**ADDENDUM NO. 3
TO
INVITATION FOR BIDS**

**IFB-19-HHL-001
ANAHOLA FARM LOTS WATER PROJECT, PHASE II –
WATER TANK REPLACEMENT & FACILITY IMPROVEMENTS**

**ANAHOLA FARM LOTS WATER PROJECT, PHASE I –
WATER TANK REPLACEMENT & FACILITY IMPROVEMENTS
PUBLIC WATER SYSTEM NO. 432
ANAHOLA, KAUAI, HAWAII**

CONTROL BUILDING EXTERIOR BUILDING SIDEWALK AND CONCRETE SLAB DETAIL
C-4 DT-7 SCALE: 1" = 2'-0"

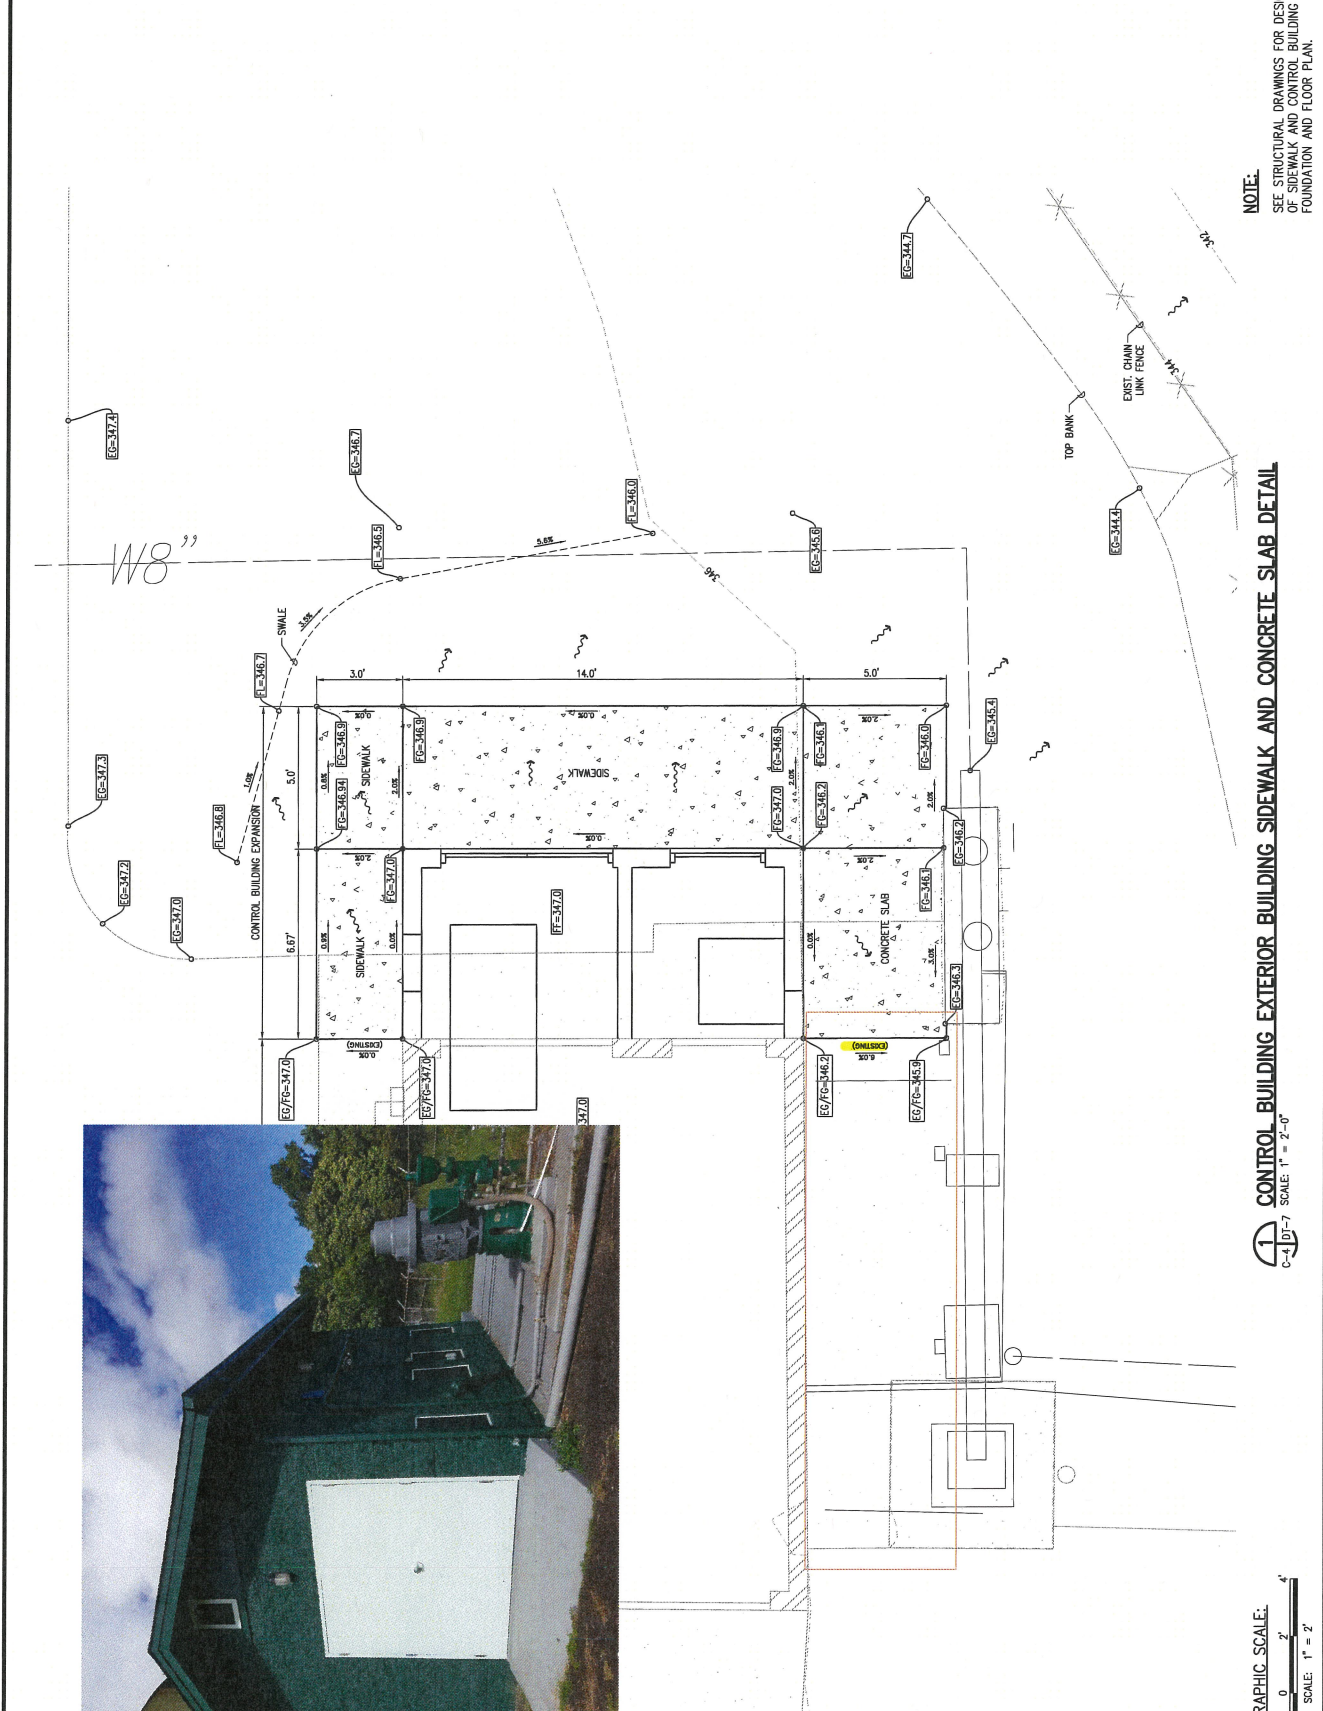
Cut Concrete?
if not please list conduit type for surface mount
stainless steel strut mounted to concrete with anchors?

See comments on RFI in blue.

ELECTRICAL EQUIPMENT ELEVATIONS - WEATHERHEAD
SCALE: 1/2"=1'-0"

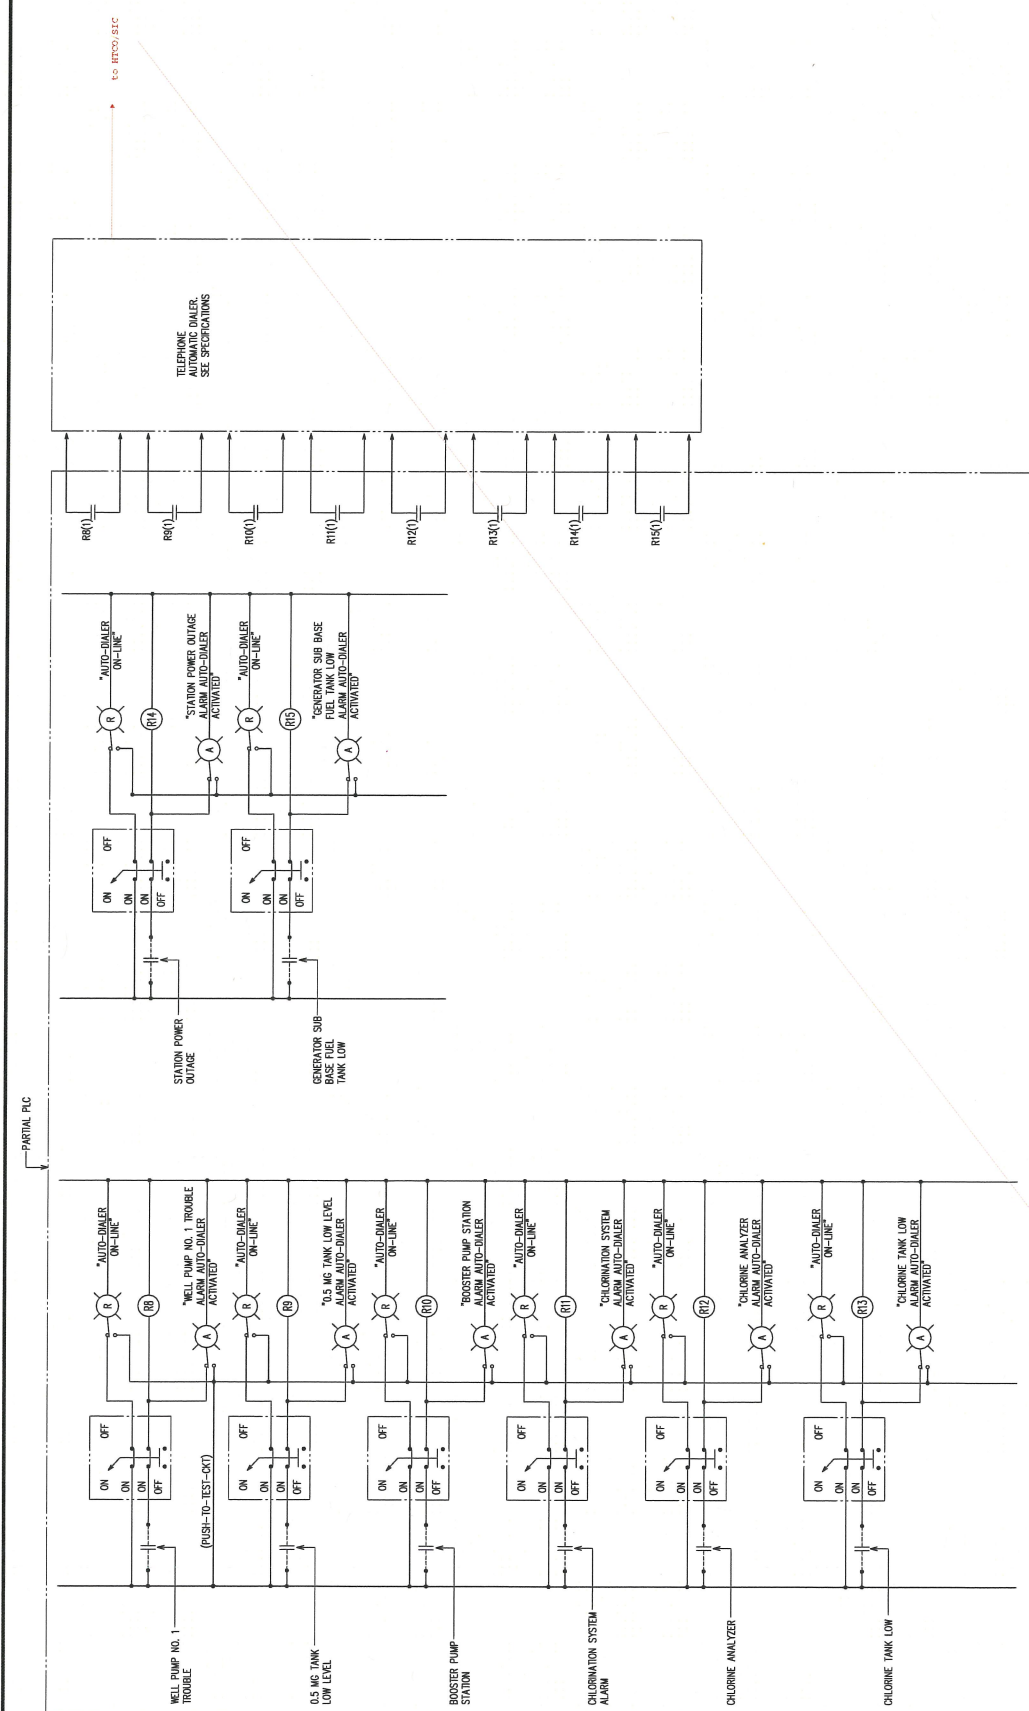
NOTES:
 1. AUTO-DIALER ALARM CONTROL SYSTEM SHALL BE PART OF SCADA TOUCH PANEL.
 please provide details on RTD/SIC connection to auto dialer system

CONDUIT SHALL BE ROUTED ALONG SURFACE. PROVIDE STAINLESS STEEL STRUTS AS REQUIRED.

UTILITY PLAN

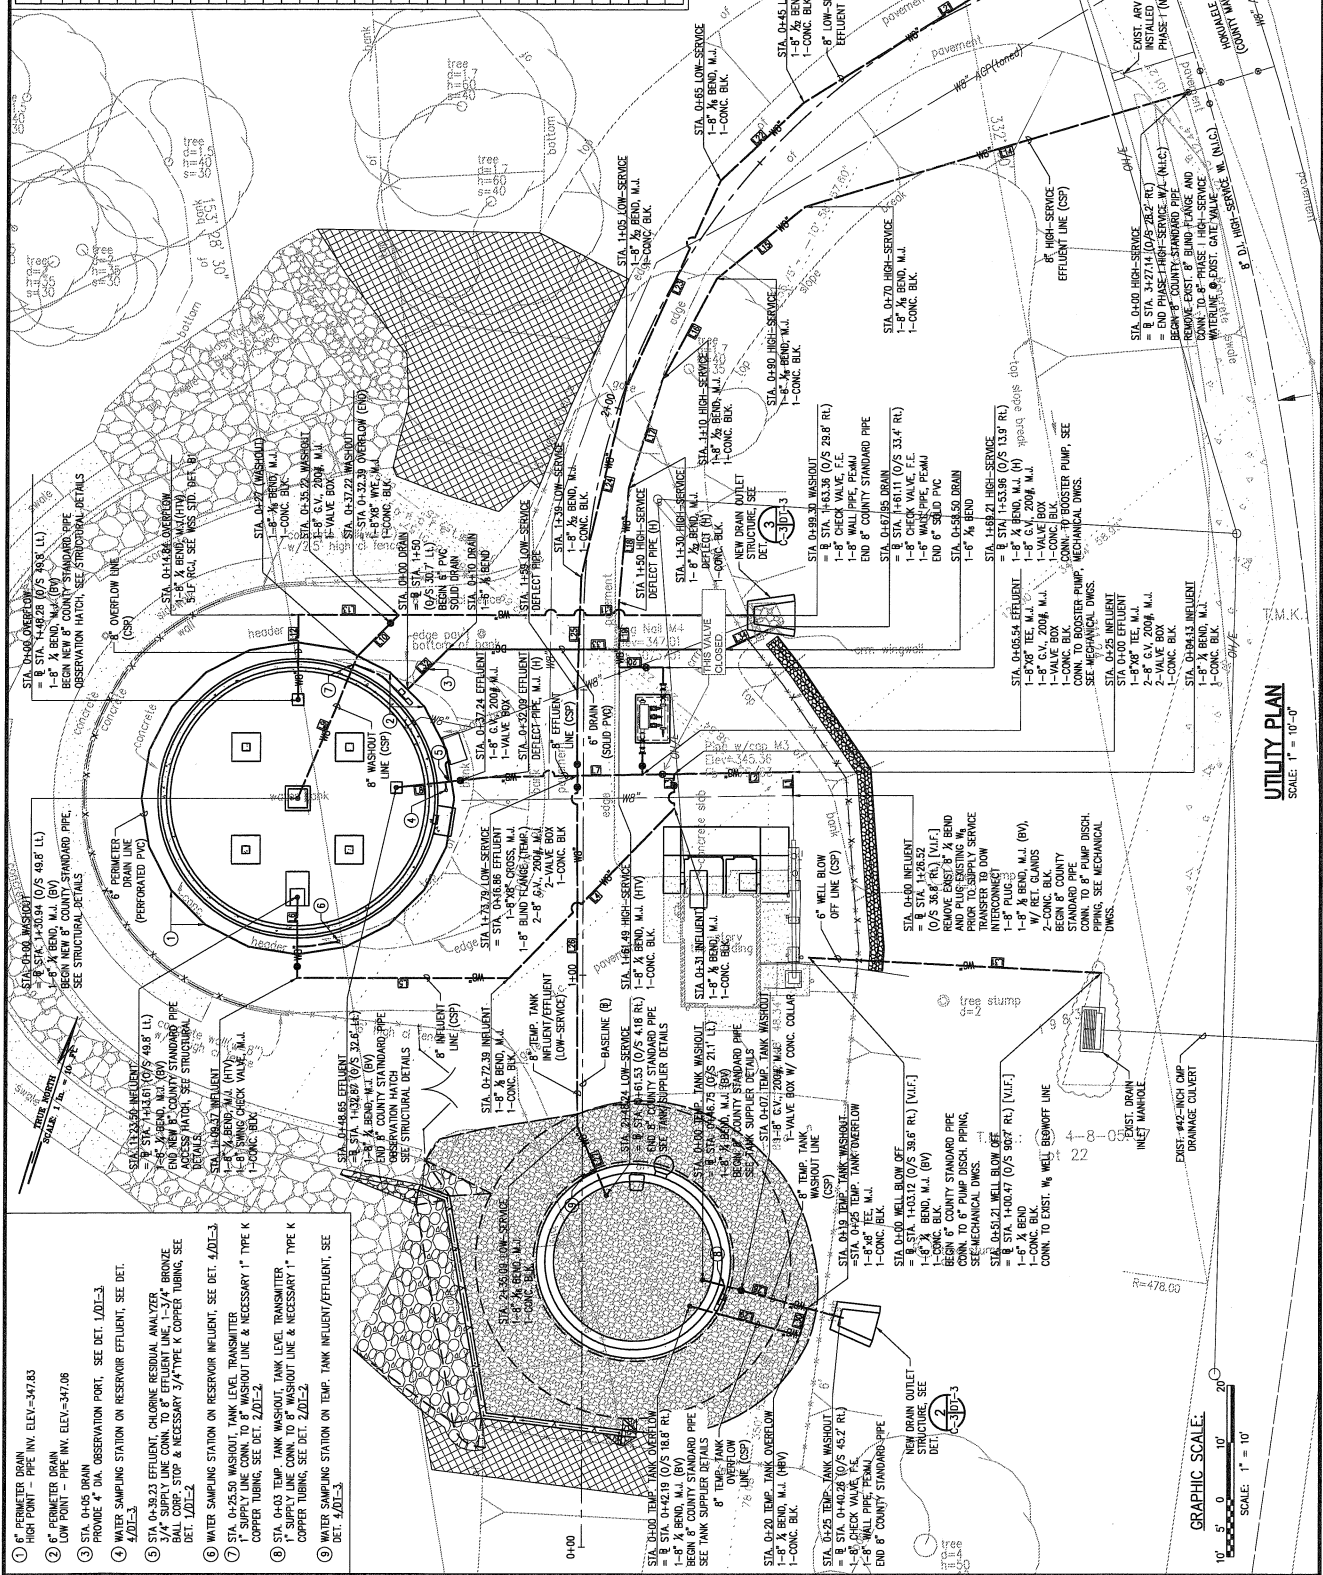
- 2. Drawing M-6 shows a chlorine residual analyzer located in the control bldg., this unit the water from the 8" main line by the control bldg. Drawing C-3 shows a chlorine analyzer sampling the same 8" effluent line from the tank. The injection point for chlorine is located off well head piping shown on drawing M-1, the analyzers are reading the same line. Are both analyzers necessary and if so which analyzer triggers the dosing pump?**

The two analyzers are required. The one in the control building measures the chlorine residual downstream of the injection point as required by DOH. This is off the reservoir influent line. This analyzer controls the metering pump. The analyzer on Drawing C-3 is off the reservoir effluent line and measures chlorine residual before it goes into distribution. There is a valve which will remain in the closed position between the influent and effluent lines. See attached sheet C-3 with the valve identified.
